**DRAFT Preliminary Review:  
Navy Groundwater Flow Model  
for the Navy Red Hill Facility**

*The Department of Health Hawaii (DOH)  
Technical subject matter experts  
Robert Whittier, Don Thomas, G.D. Beckett & Anay Shende*

*February 12, 2021*

# GW Elevation Variance – Transient Models

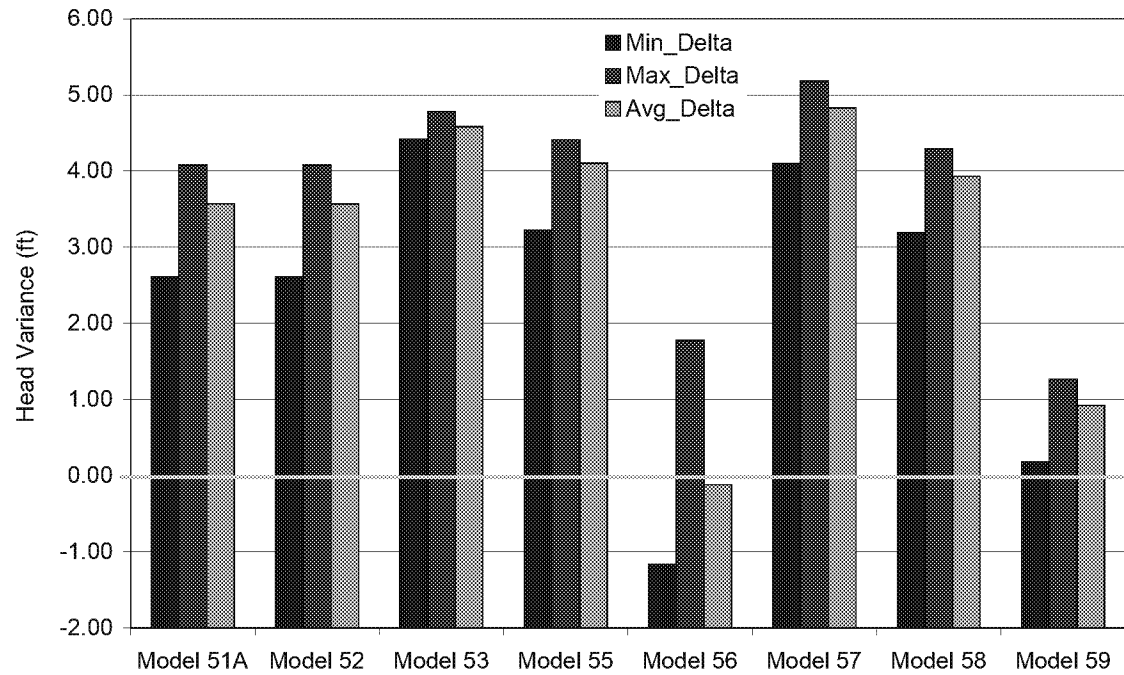
Modeled Groundwater Elevations Compared to Actual Synoptic Data  
Verification Model Variances to Measured Red Hill Area Well
